Site Plan Narrative & Aesthetic Design Criteria

PROPOSED BALLROOM FOR:
VISTA GARDENS
 5011 W. HILLSBORO BLVD
 COCONUT CREEK, FL
JOSE SALCEDO

SHEET TITLE
WATER & SEWER PLAN
 CS of 9

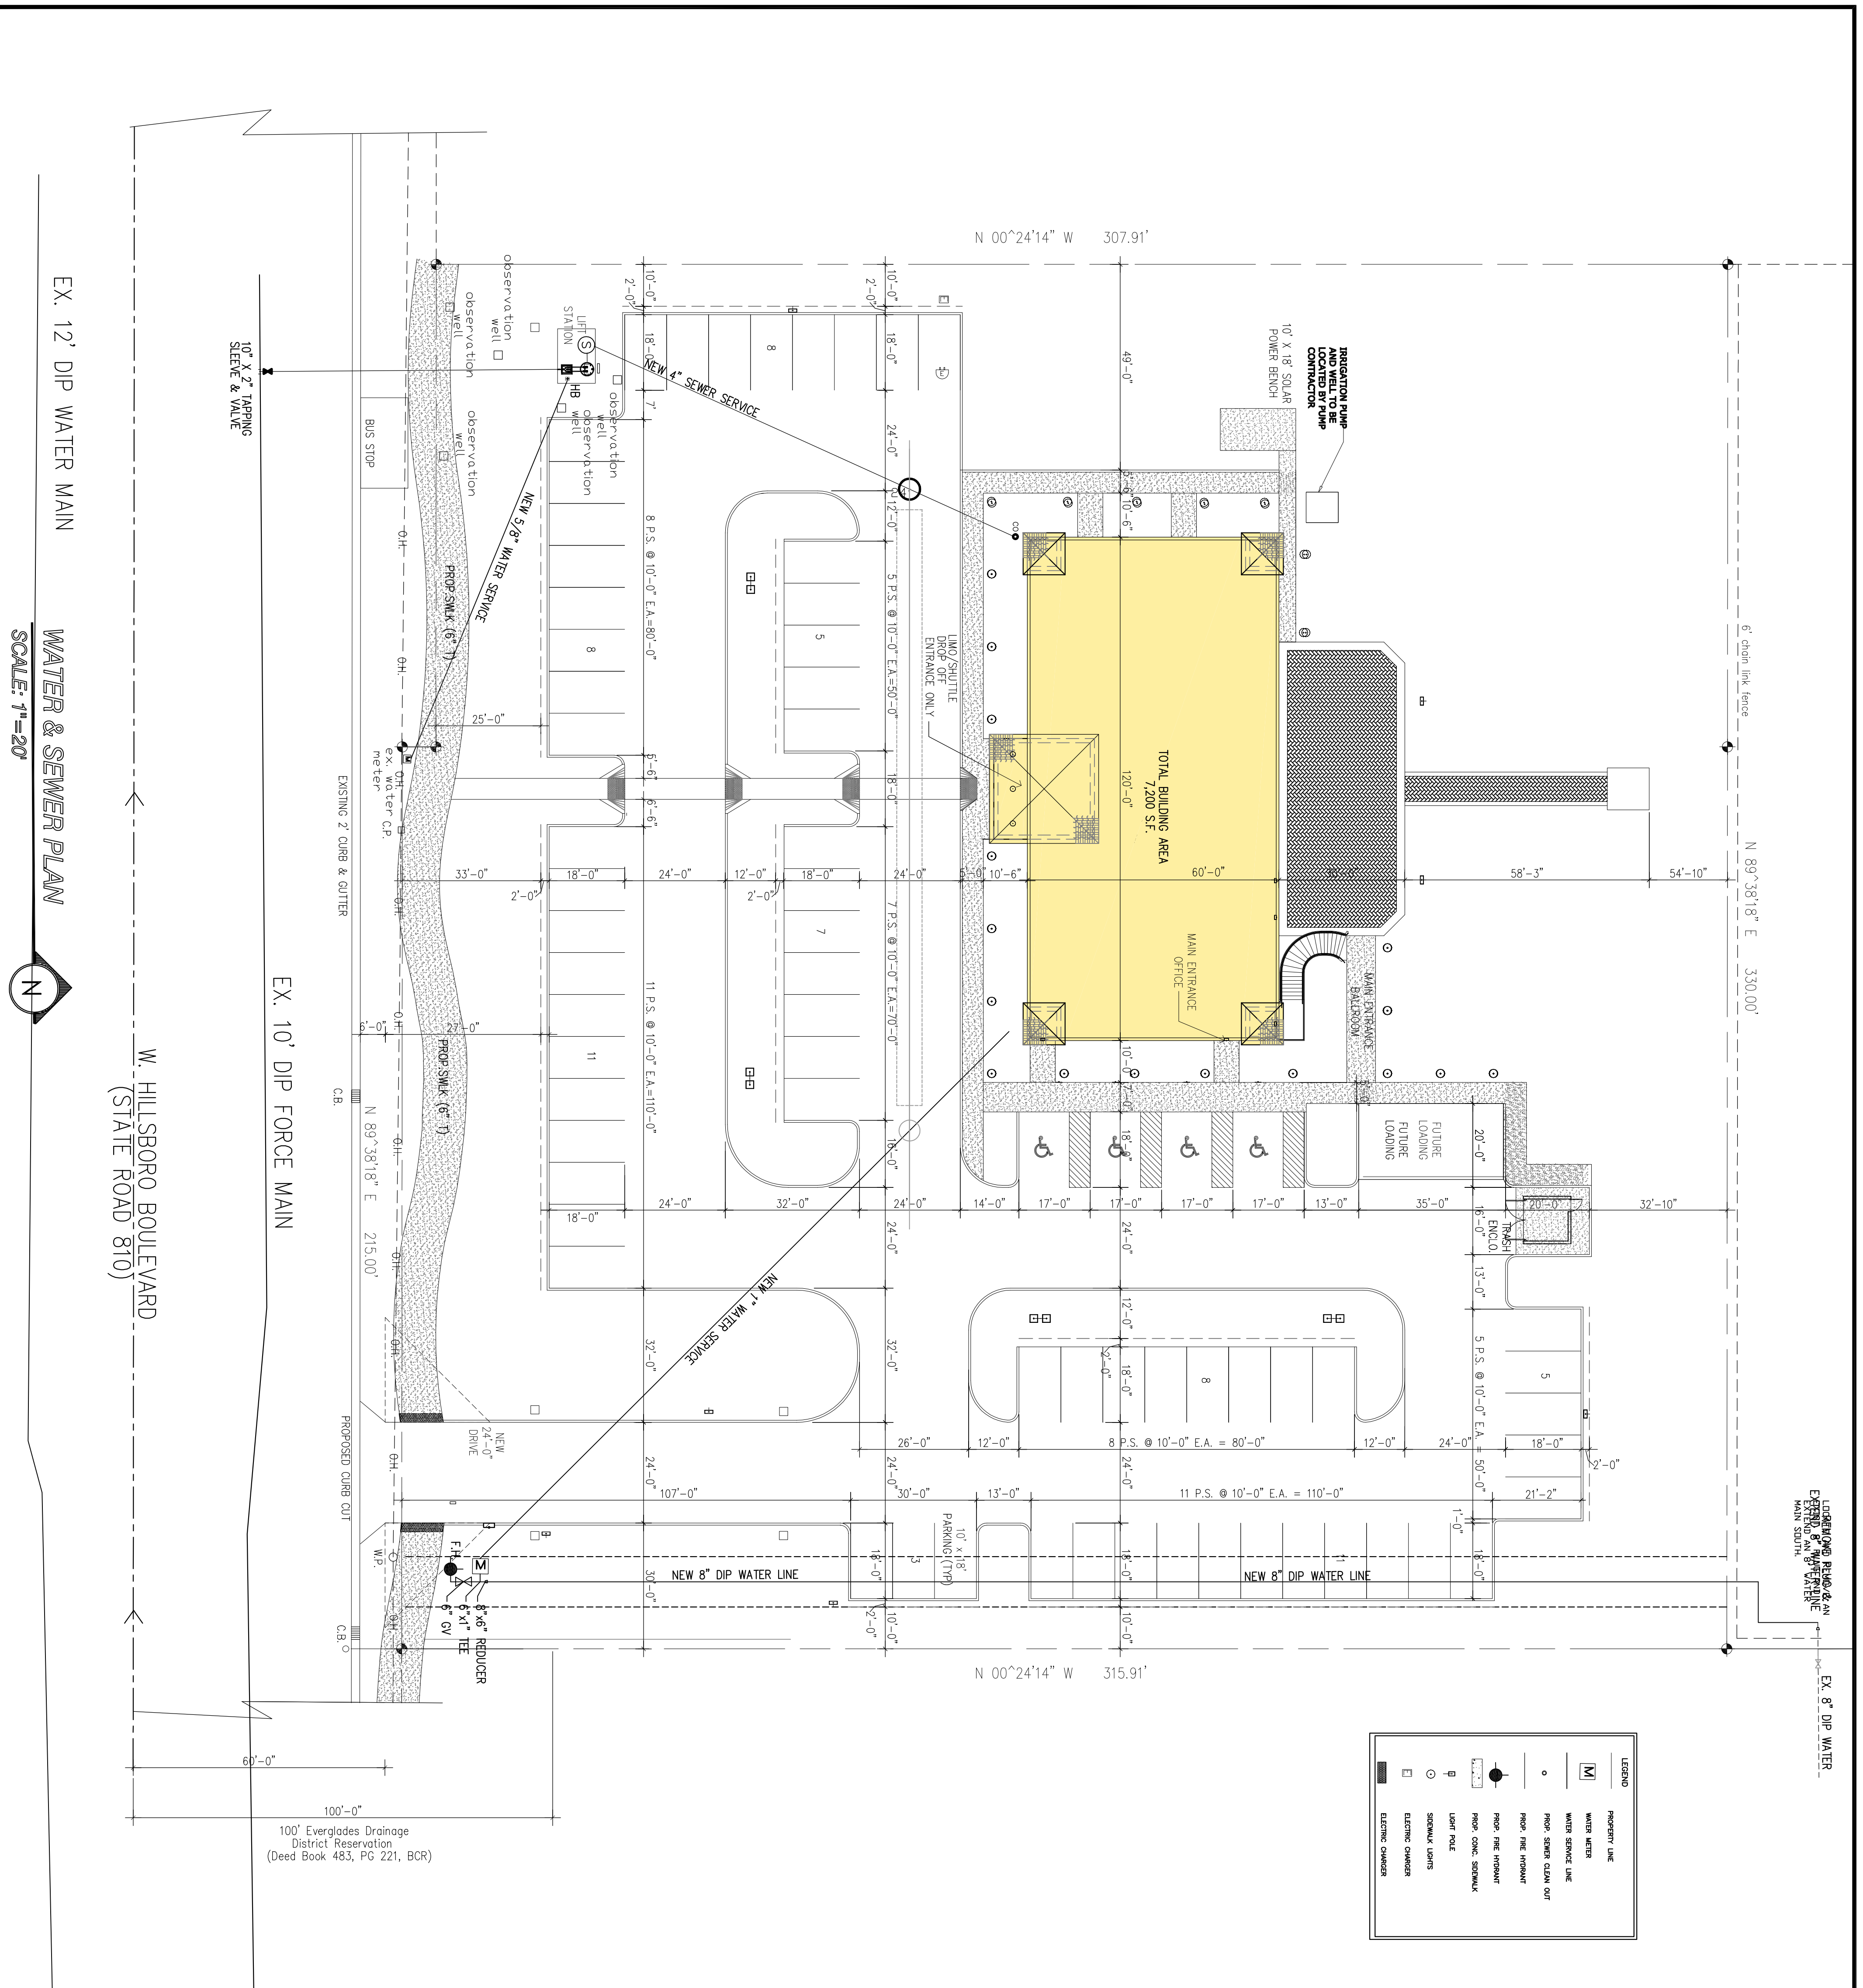
- The Proposed Lift station location seems to be in conflict with existing water service, please clearly.
Response: Are the existing observation wells to remain (see survey), if so they are in conflict with them not water service.

- Make sure that all FFE are in **NAVD 88.**
Response: See note 2 of the General Notes and the FFE indicates NAVD.
- Show all proposed/existing Easements for sewer and water.

Response: Provided as required.
- Provided a 12' easement for the proposed water main, hydrant, and water service line up to the water meter.
Response: A 12' easement for the proposed water main, hydrant, and water service line up to the water meter has been provided as required.

- Show the connection point between the proposed water main and the existing water stub on the northeast side of the property.
Response: The connection point between the proposed water main and the existing water stub on the northeast side of the property.

- Provide a conflict schedule to show all conflicts/crossing between all of the proposed/existing utilities.
Response: Conflicts/crossing between all of the proposed utilities have been shown.

- Conflicts between water, wastewater and drainage shall be minimum separations according to Florida Administrative Code (FAC) Rule 62-555.31.
- **Response: Conflicts between water, wastewater and drainage have been provided with minimum separations according to Florida Administrative Code (FAC) Rule 62-555.31.**

SIGNING & MARKING PLAN
SCALE: 1"=20'

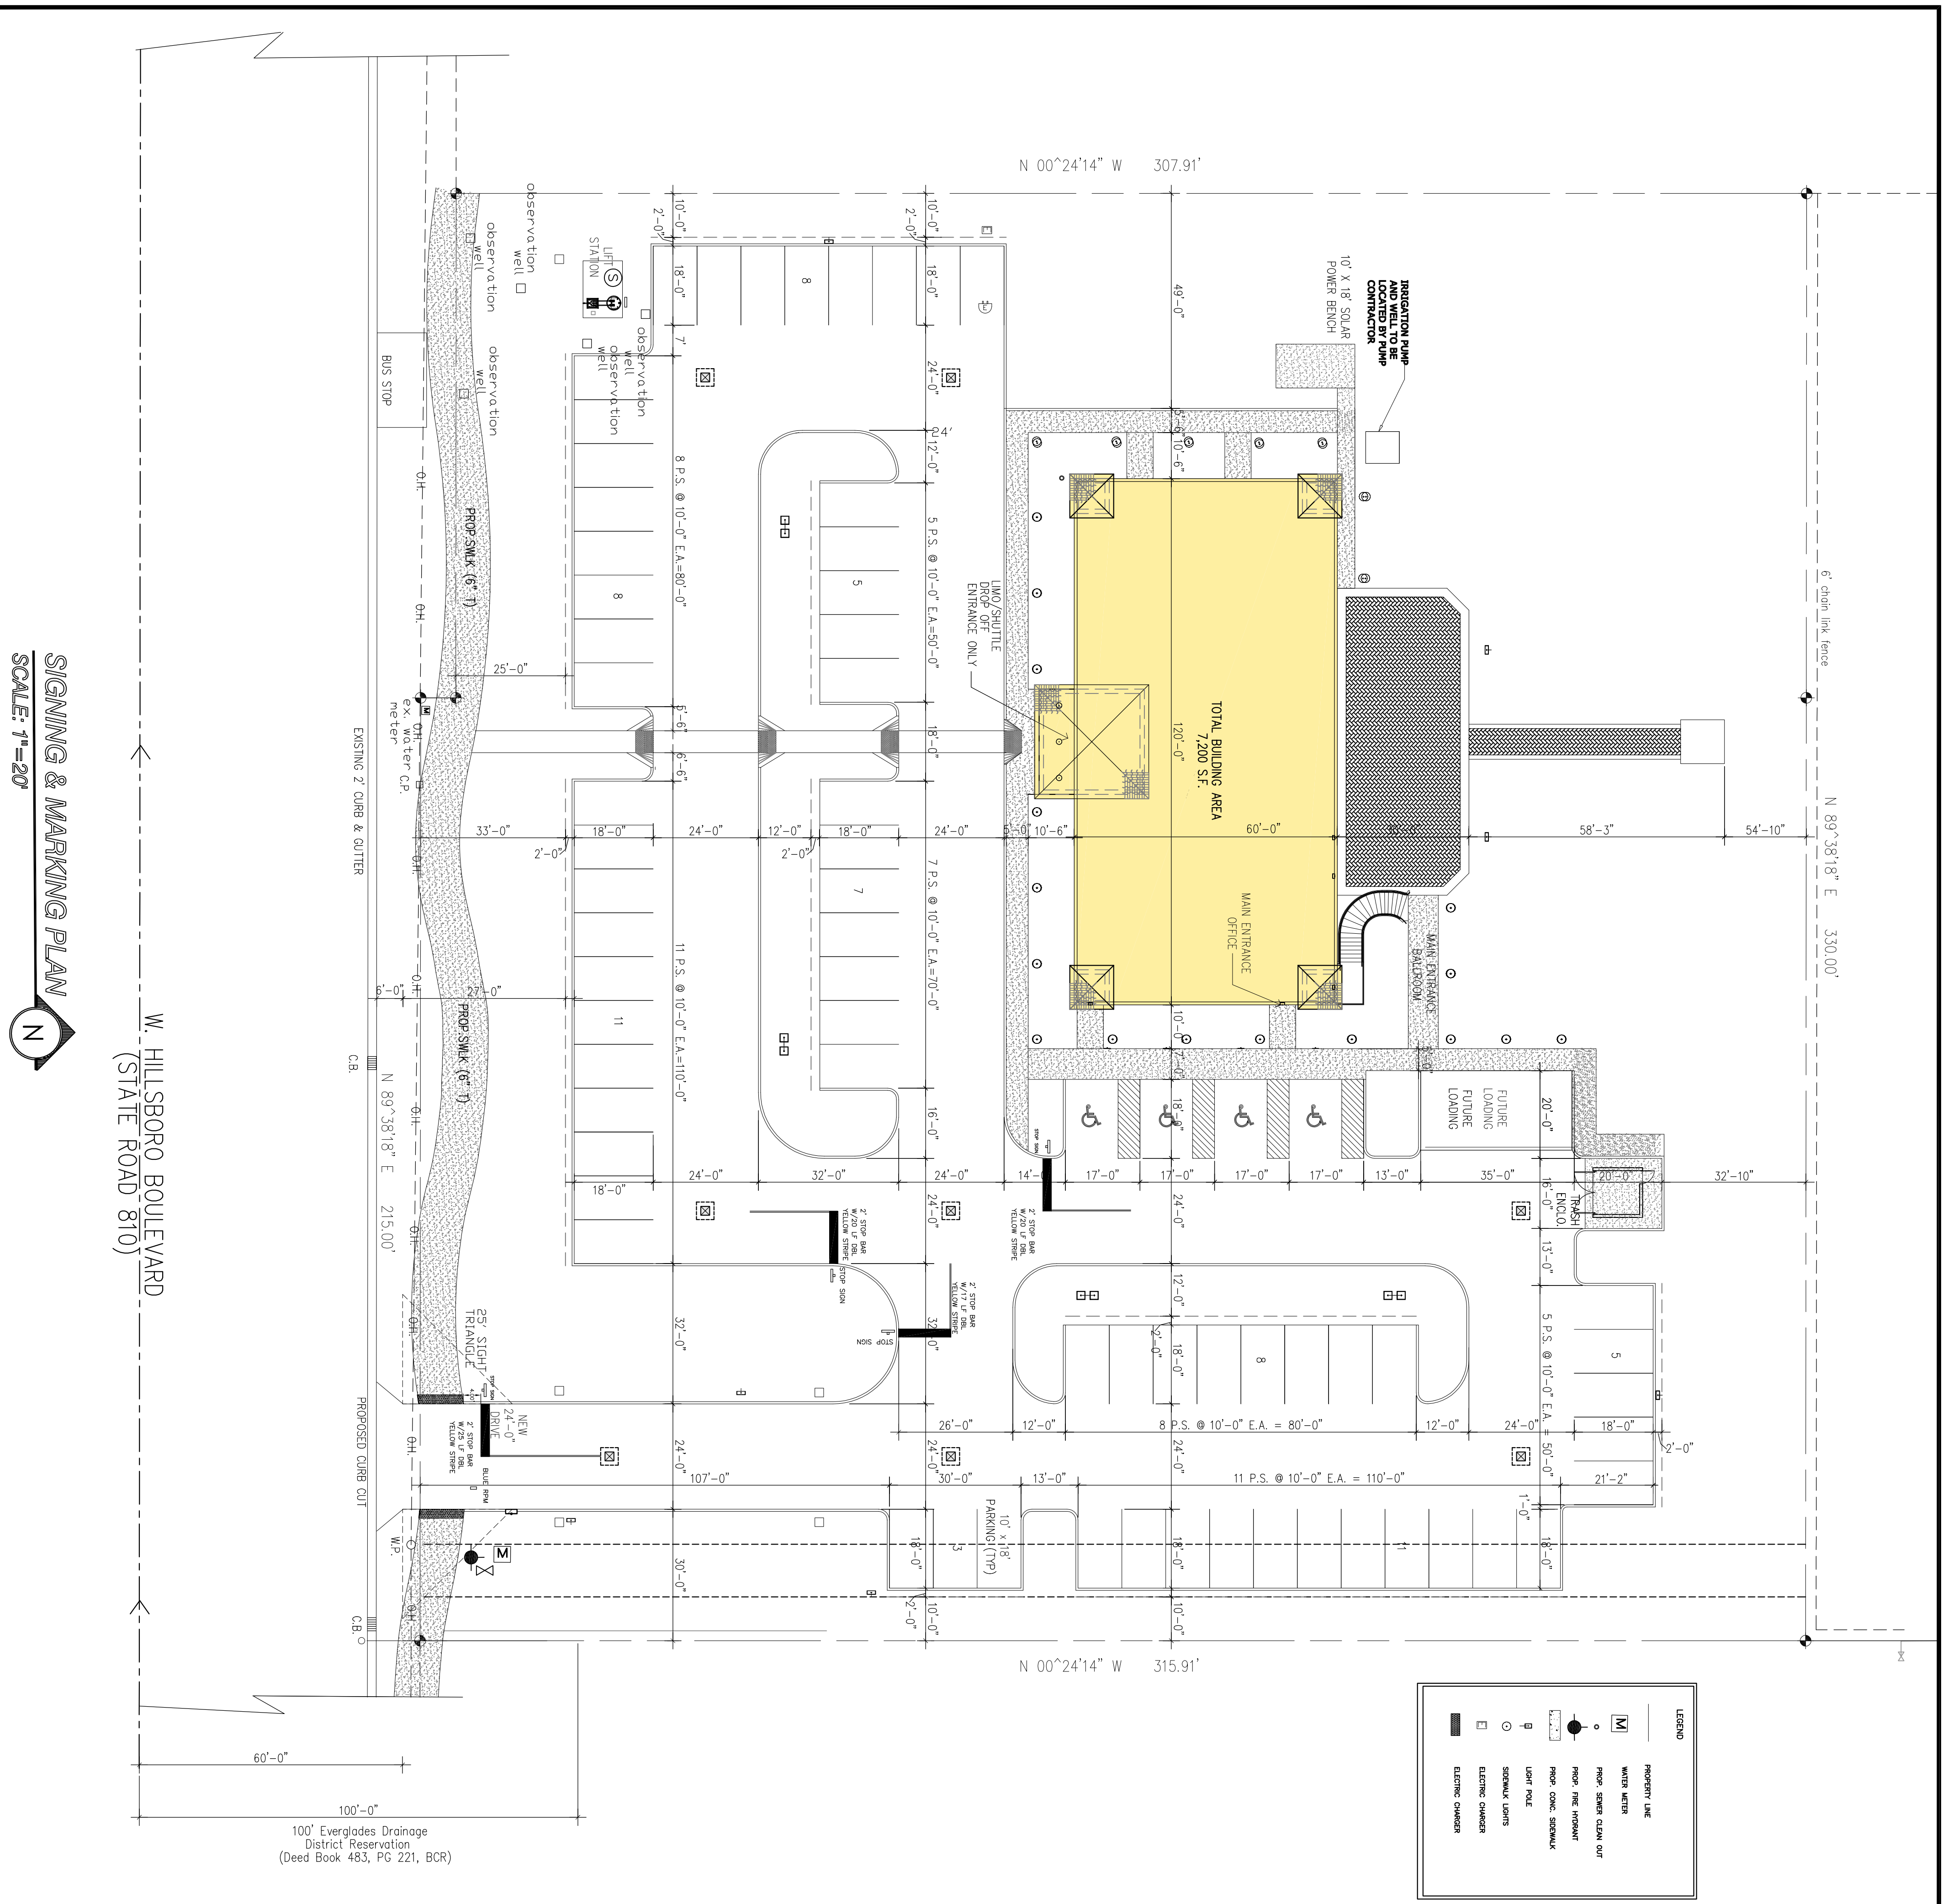
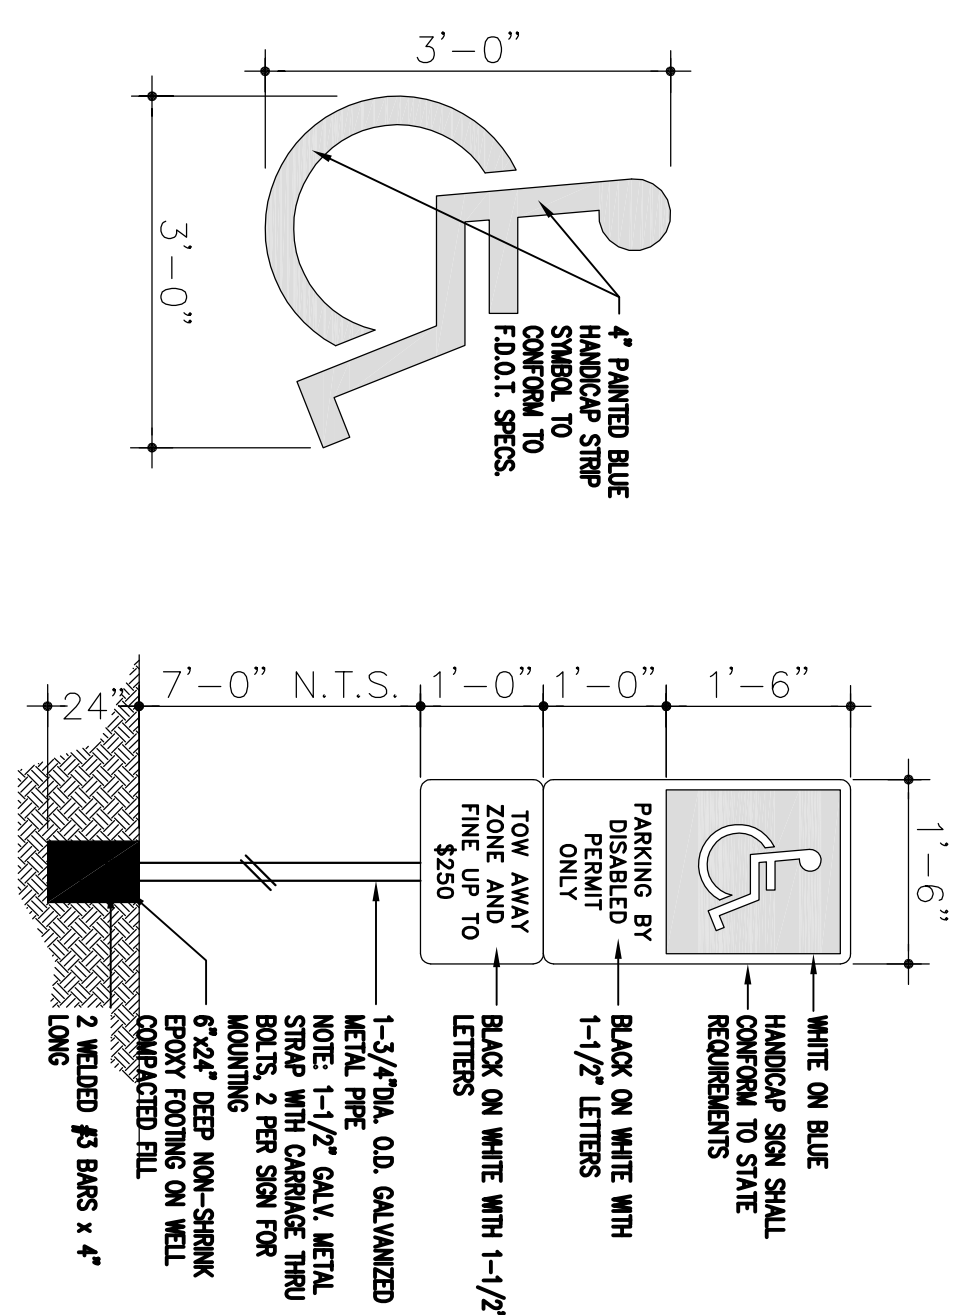
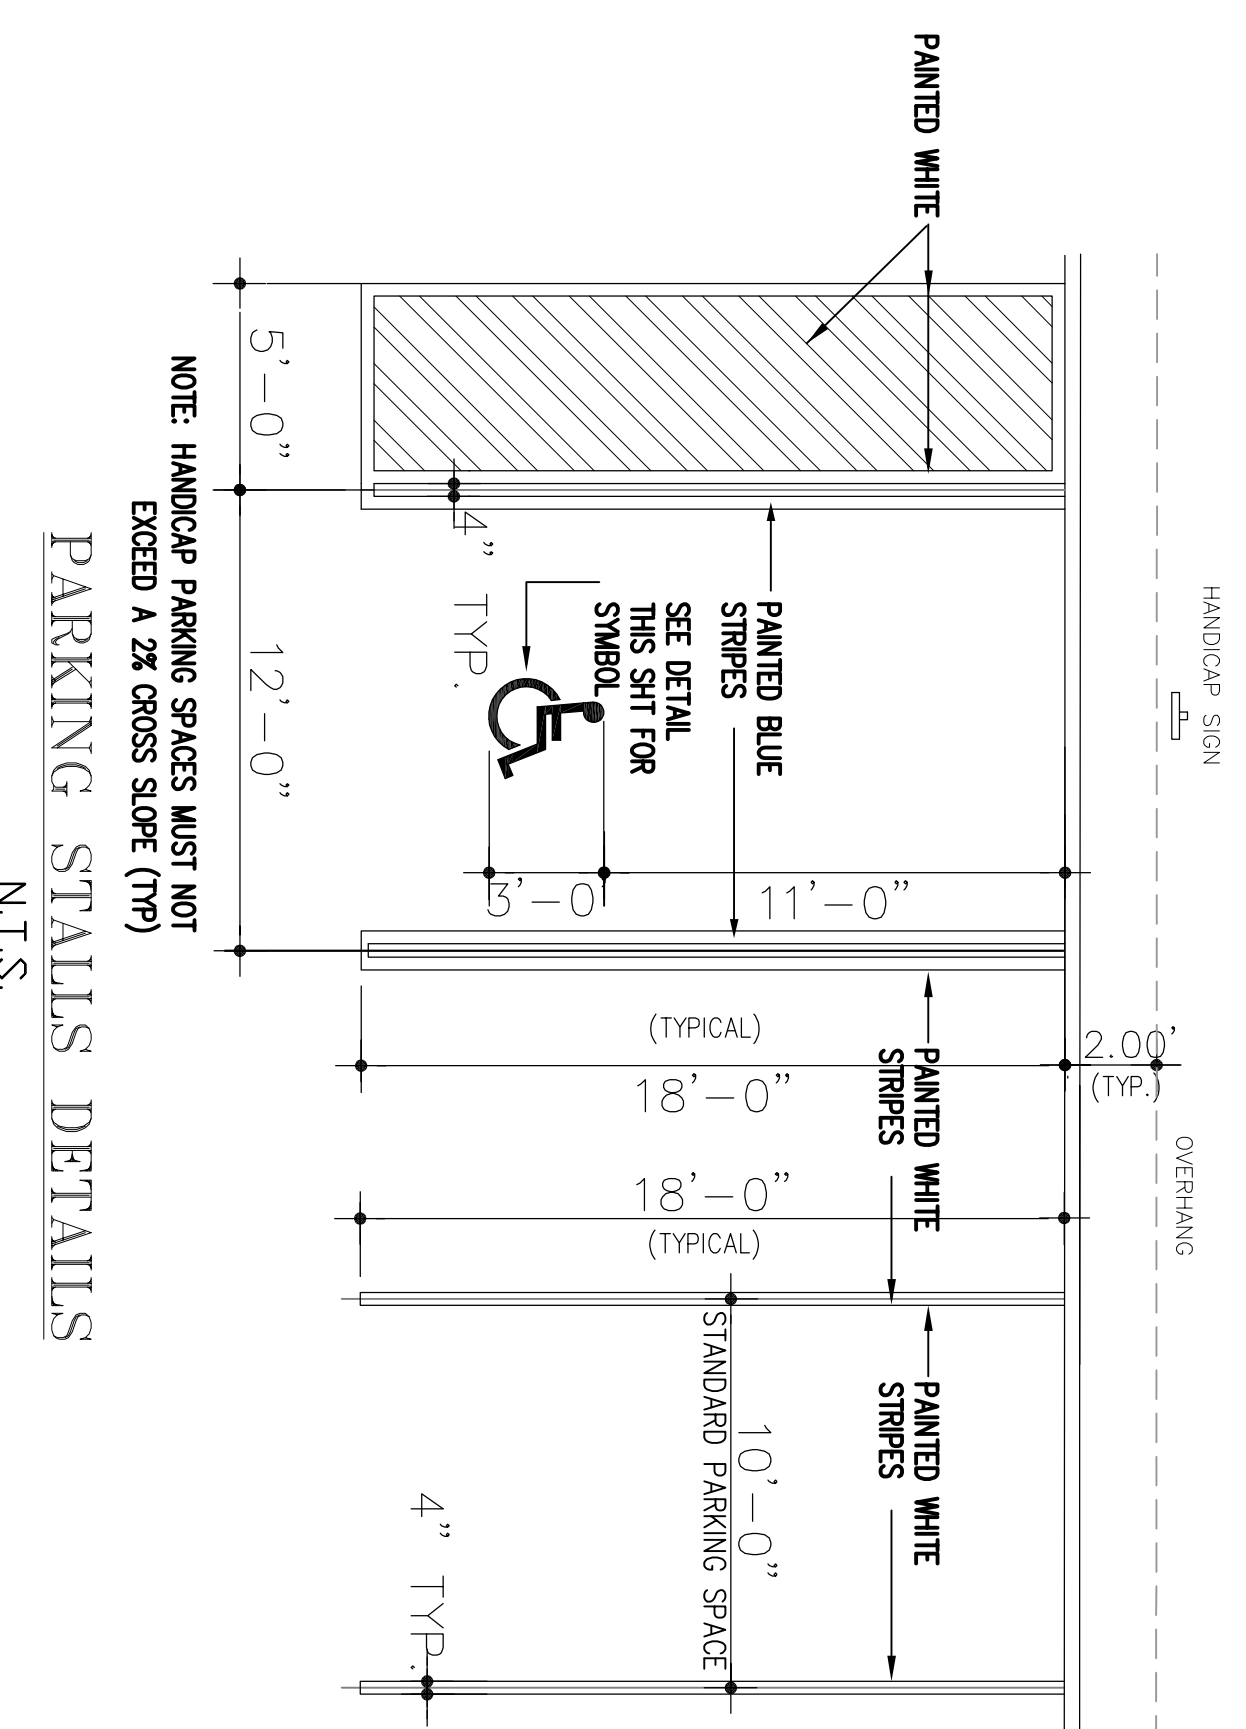
- Show all proposed signage on plans with details.
Response: All proposed signage was shown on the plan.
- No trees allowed within 5 feet of swales centerline.
